HISTORIC LANDMARKS COMMISSION

STAFF REPORT AND FINDINGS OF FACT

SUBJECT: NEW CONSTRUCTION REQUEST (NC18-02) TO CONSTRUCT A
DETACHED GARAGE/ACCESSORY DWELLING UNIT FOR AN EXISTING
SINGLE-FAMILY DWELLING AT 500 DUANE STREET

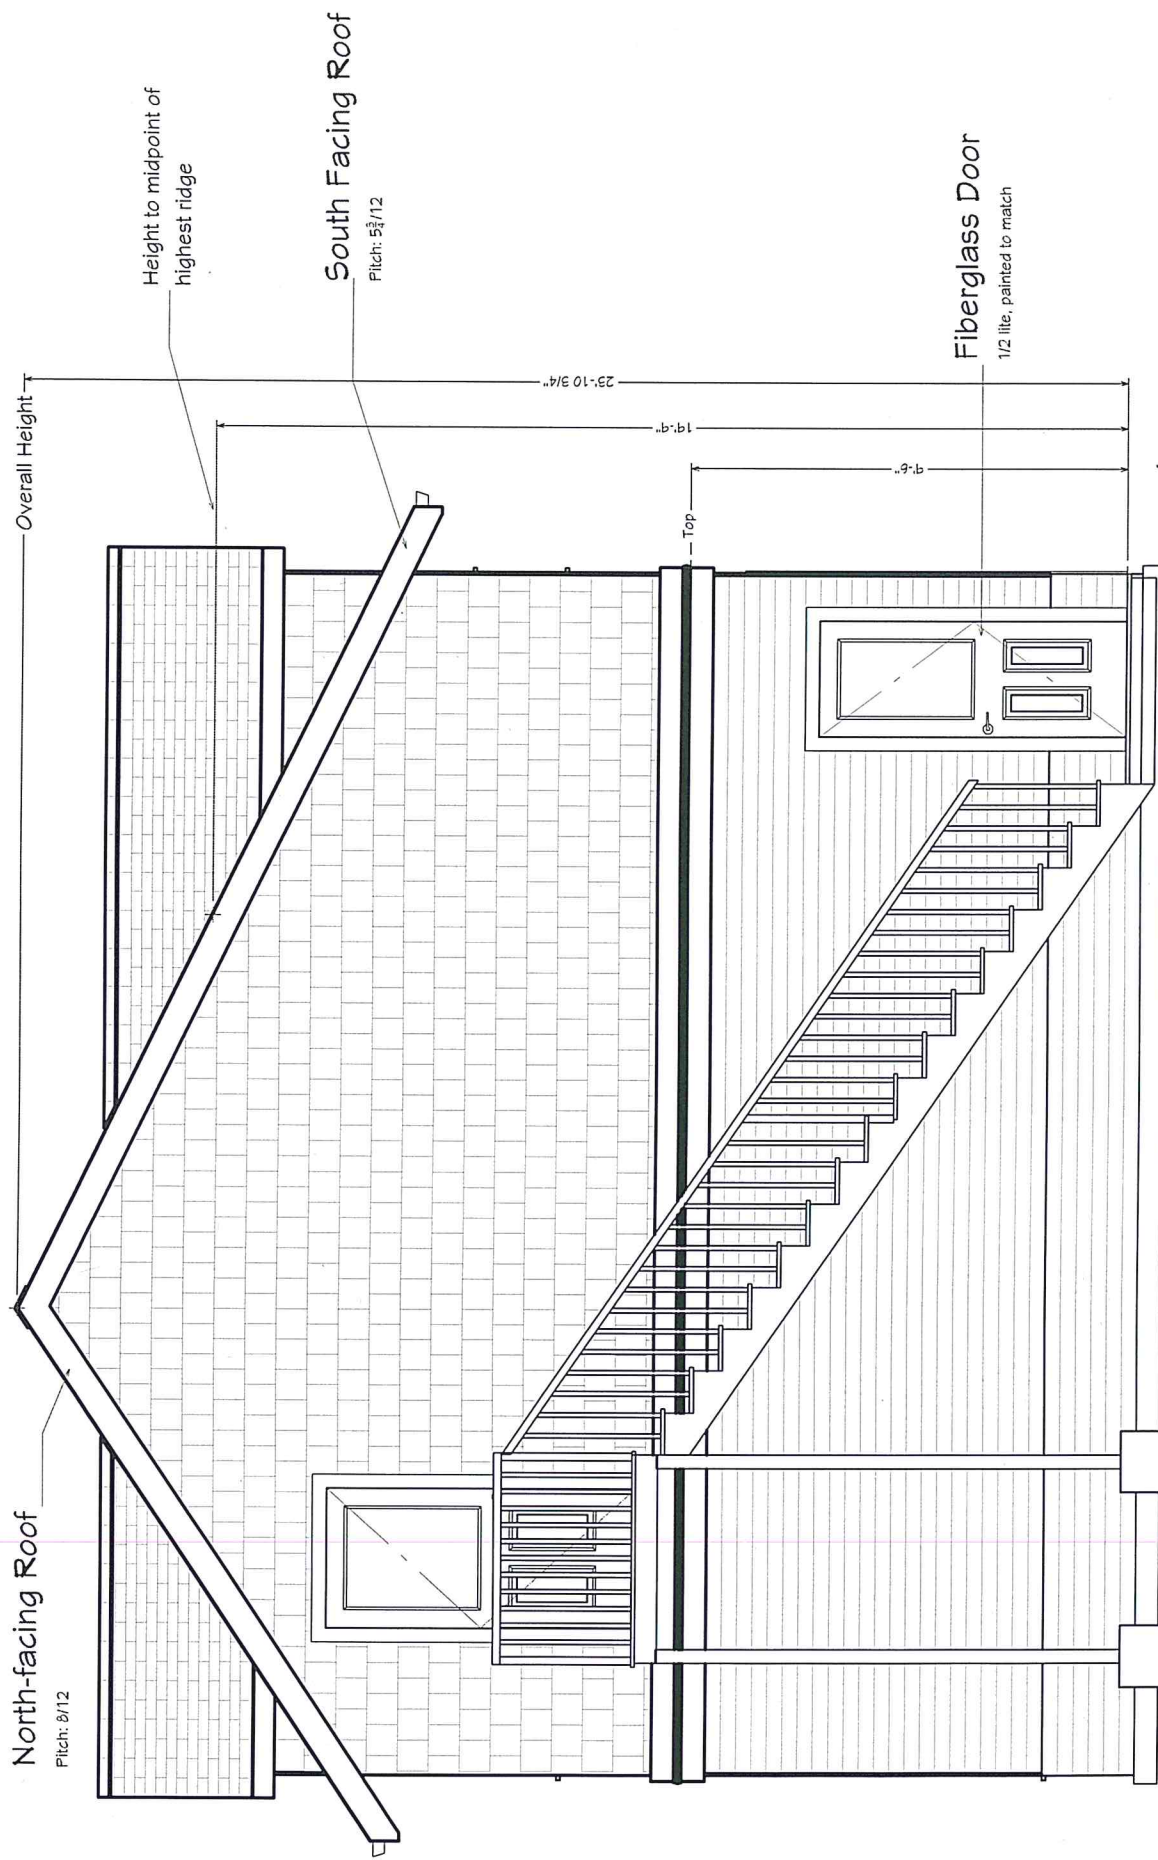
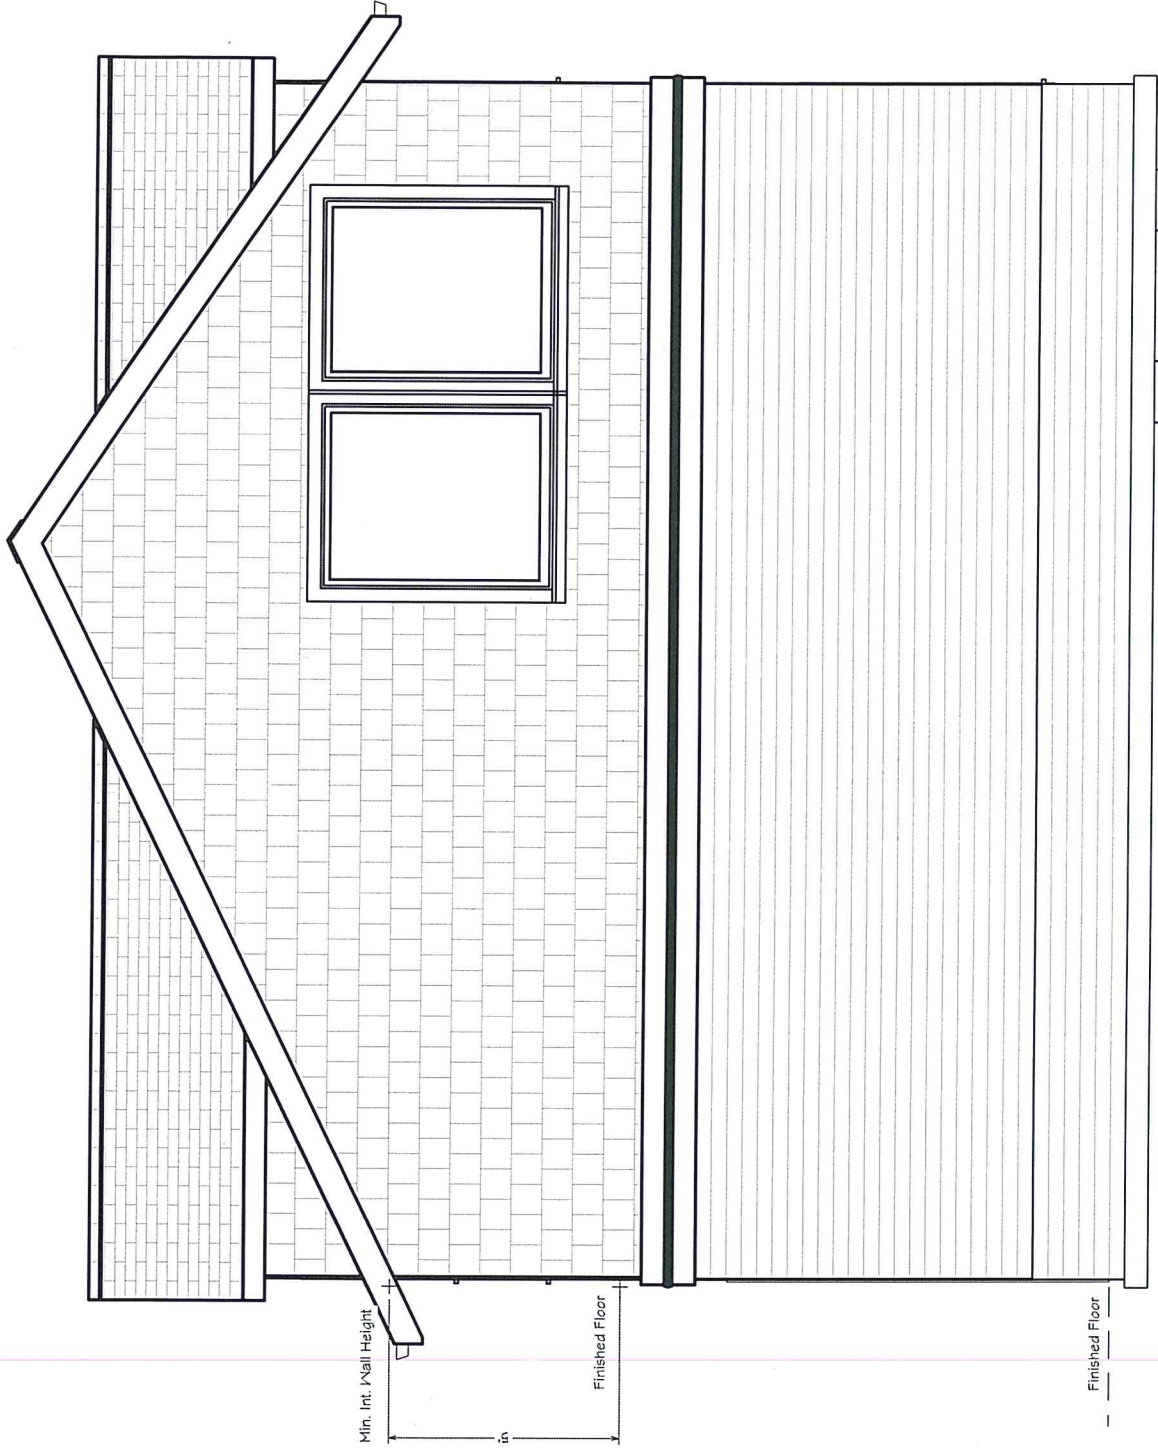
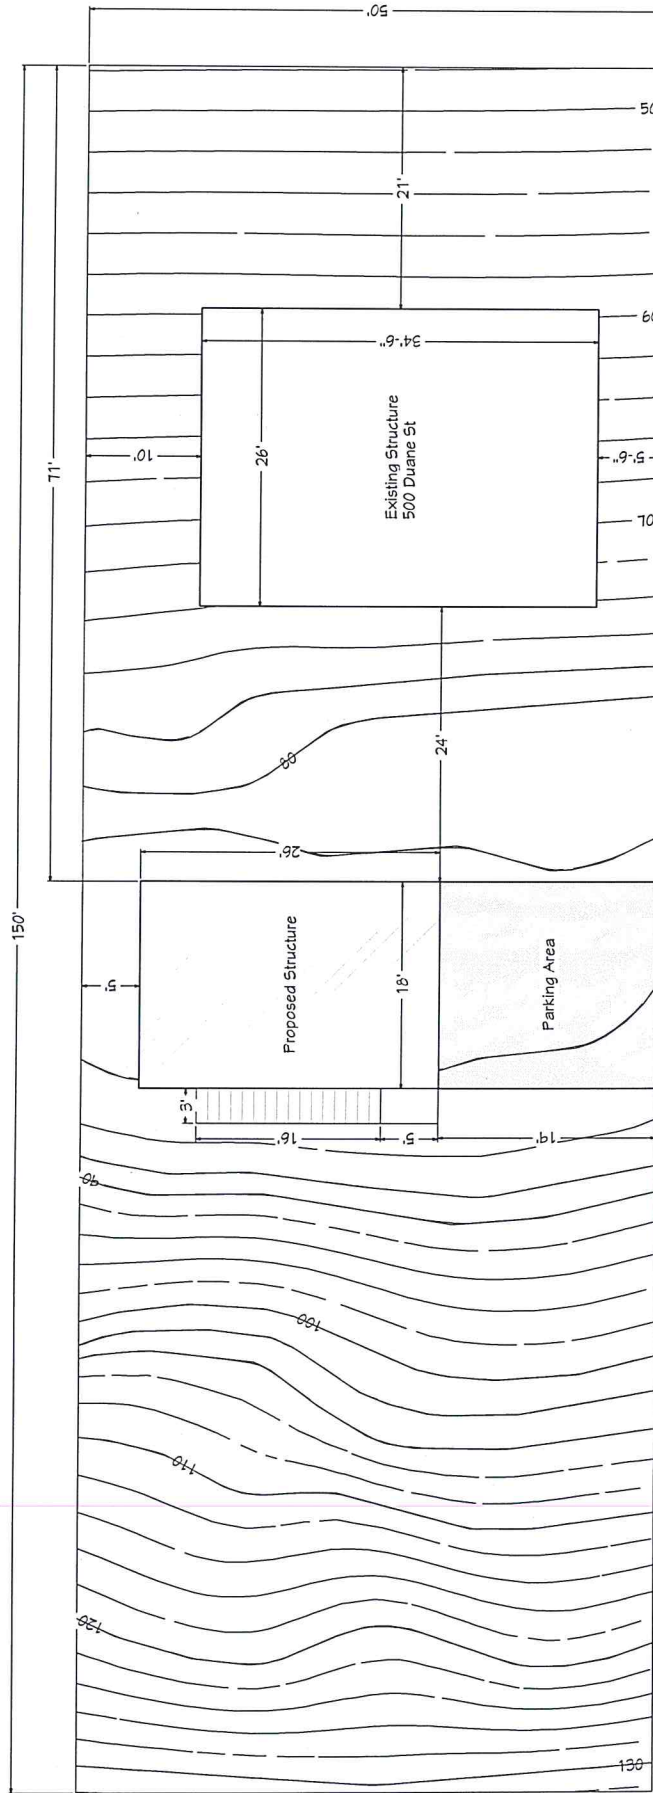
The proposed structure would have a side gable roof with front and rear dormers. The roof is elongated toward the front of the structure similar in design to the roof of the SFD on the site. However, the front of the garage faces south, to the elongated roof is on the south of the garage while it is on the north of the house. When constructed, the garage will set parallel to the house and the roof slopes will be opposite of the house. The HLC will need to determine if the roof should be reversed so that both of the long sides face north and the short sides face south. If the HLC determines that it should be reversed, a revised plan shall be submitted to the Planner for review and approval (Condition 5).

The roof would have an 8:12 pitch and the dormers would have a 6:12 pitch. These pitches would be similar to the existing SFD roof but there would not be a flair. The house has deep eaves with end returns. The garage eaves should be the same depth as the main house (Condition 6). Eave returns should be added (Condition 7). Roofing is proposed to match the existing composition shingle. The City's "Rehab Astoria Right" guide for citizens states *"While the roof line does not have to match the house, it is best that it not vary significantly."*

No windows are proposed on the left west side which would face the steep hillside and would have two man-doors and stairs to the 2nd floor. The man-doors would be 1/2 single lite, fiberglass, panel doors painted to match the house. If the garage will be used by the main dwelling, the location of the ground floor man door would be better located on the east side of the garage adjacent to the dwelling. Should the applicant decide to install a man door on the east side, it would be compatible.

The right east side facing the main house would have two fixed pane single lite windows on the second floor. These windows would provide a view up the Columbia River from the second story for use as either a transient lodging facility or an Accessory Dwelling Unit. The historic SFD on the site has one over one double hung wood windows.

5. If the HLC determines that the slope of the roof should be reversed, a revised plan shall be submitted to the Planner for review and approval.
6. The garage eaves shall be the same depth as the main house.

7. Eave returns shall be added on the main and dormer roof.
8. Significant changes or modifications to the proposed plans as described in this Staff Report shall be reviewed by the Historic Landmarks Commission.

Window Construction Details

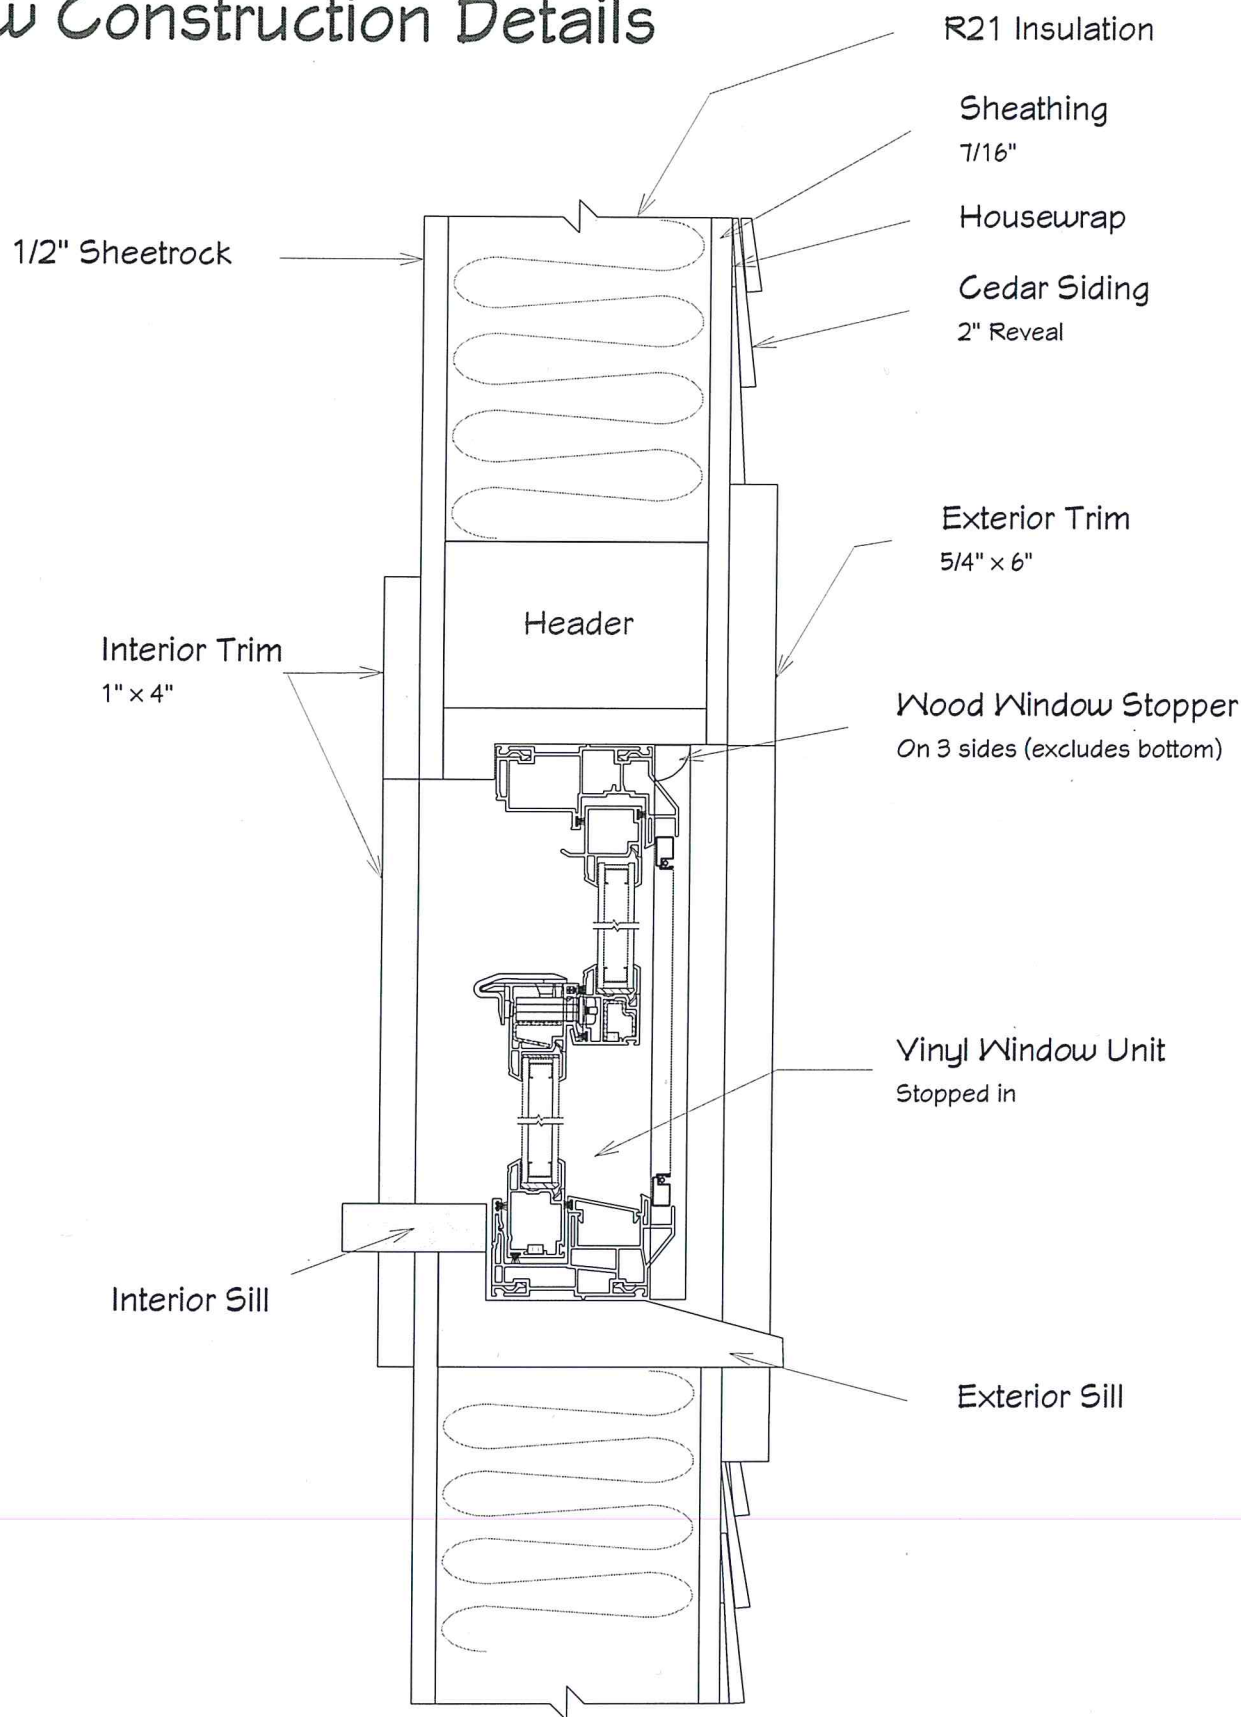
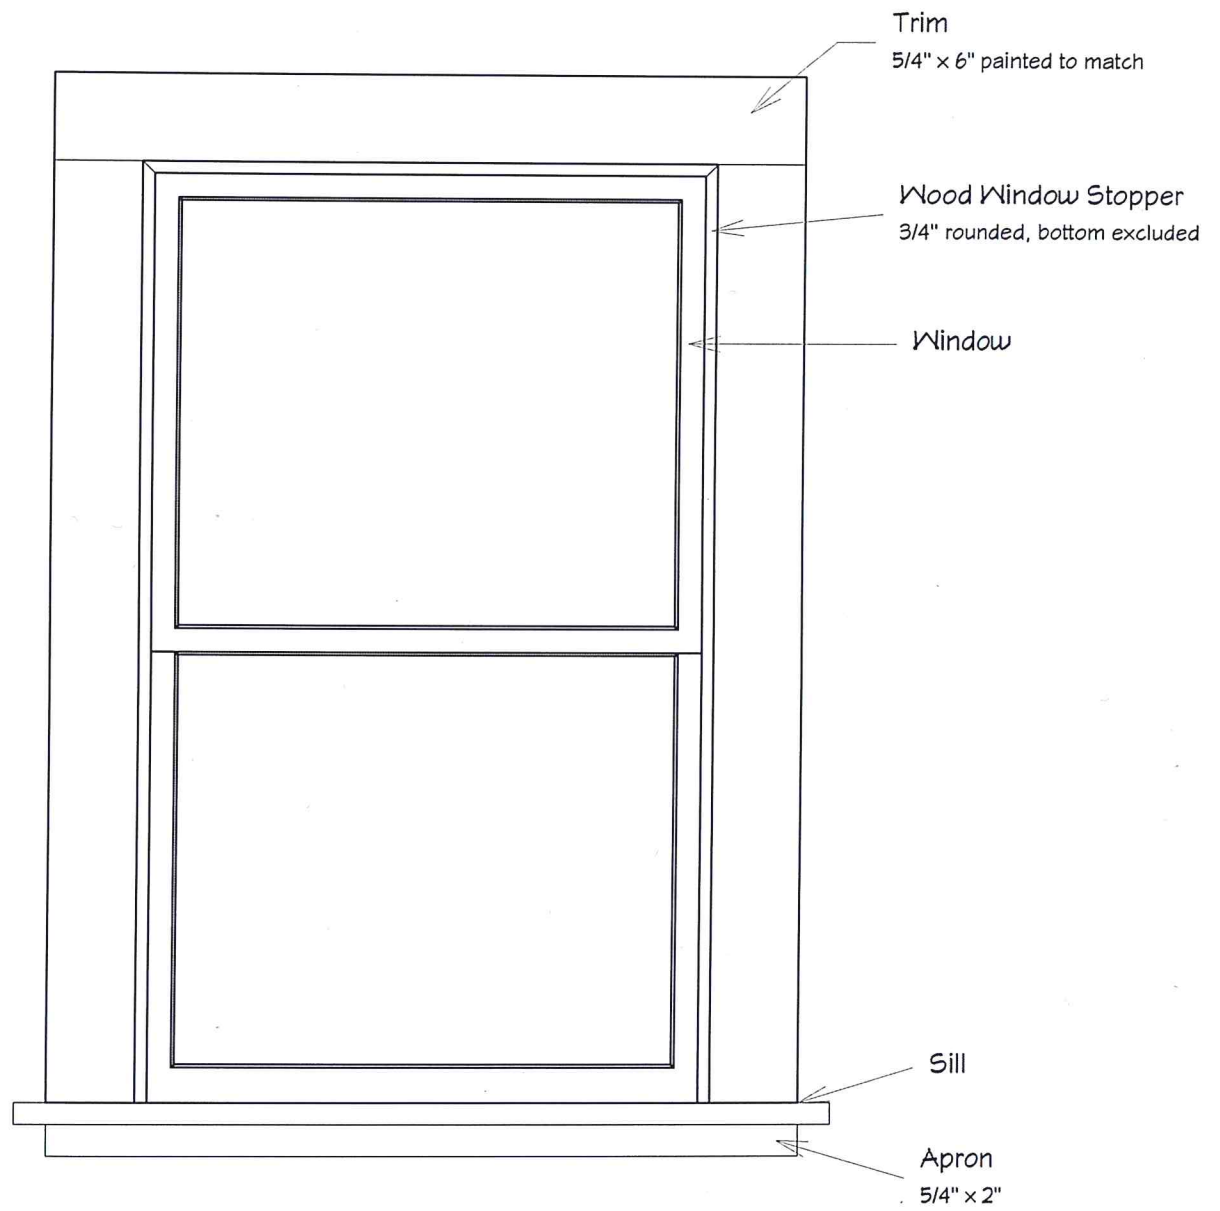
The applicant proposes to use vinyl windows with 5/4" x 6" wood casing, lower sill, and apron. The window detail provided shows the window with a minimal inset from the plane of the building. While use of vinyl material on a new construction may be compatible, the appearance of the window installation should more closely match that of the historic windows on the adjacent historic building. The windows should be inset from the plane of the house to a depth similar to the historic depth of the main structure or a minimum of at least 2" not including the casing (Condition 1).

1. The windows shall be inset from the plane of the house to a depth similar to the historic depth of the main structure or a minimum of at least 2" not including the casing.

Wrong design – supports & construction details visible

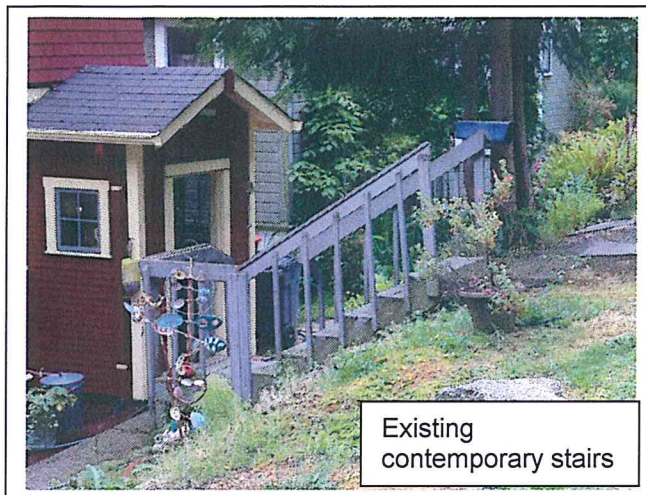
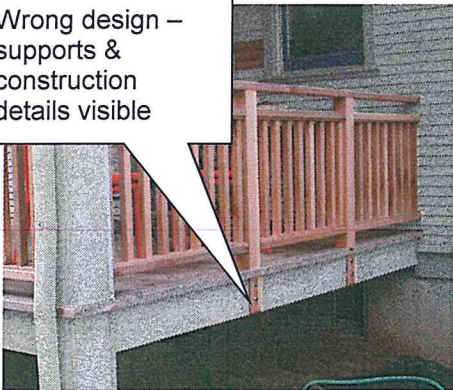
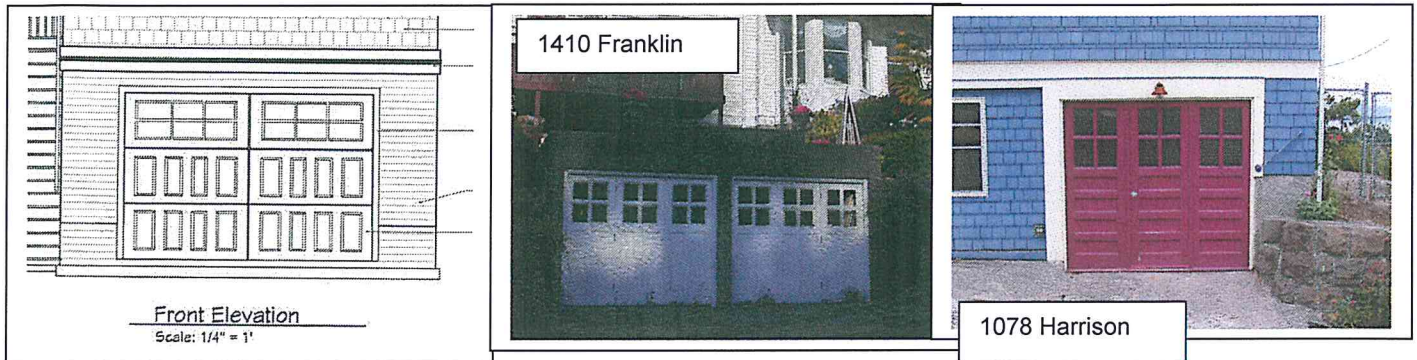
The stairs on the west side are proposed to have a balustrade with spindles ending in the decking and stairs. They should not be on the outside of the stringer or the outside of the handrail (Condition 4). The main historic structure has a solid front porch balustrade and a contemporary railing in the yard to access the lower level of the lot where the house is located, but they are not attached to the house. The proposed stairs would face the steep hillside and would not be highly visible. The design is more contemporary, but with the secluded, less visible location the design could be considered as compatible.

The materials should be compatible with typical historic design. Any exposed visible wood should not have pressure treatment incision marks visible. Support posts could be wrapped to hide the incision marks. Any construction features such as bolts should be hidden behind a fascia board and not visible. The balustrade should have a newel post at the bottom (Condition 2). All wood should be painted to match the house (Condition 3).

Correct design – supports & construction details covered

Wrong design - supports visible

2. Any exposed, visible wood shall not have pressure treatment incision marks visible. Support posts could be wrapped to hide the incision marks. Any construction features such as bolts shall be hidden behind a fascia board and/or otherwise not visible. The balustrade shall have a newel post at the bottom.

3. All wood shall be painted to match the house.
4. The stairs on the west side may have a balustrade with spindles ending in the decking and stairs. They shall not be on the outside of the stringer or the outside of the handrail.
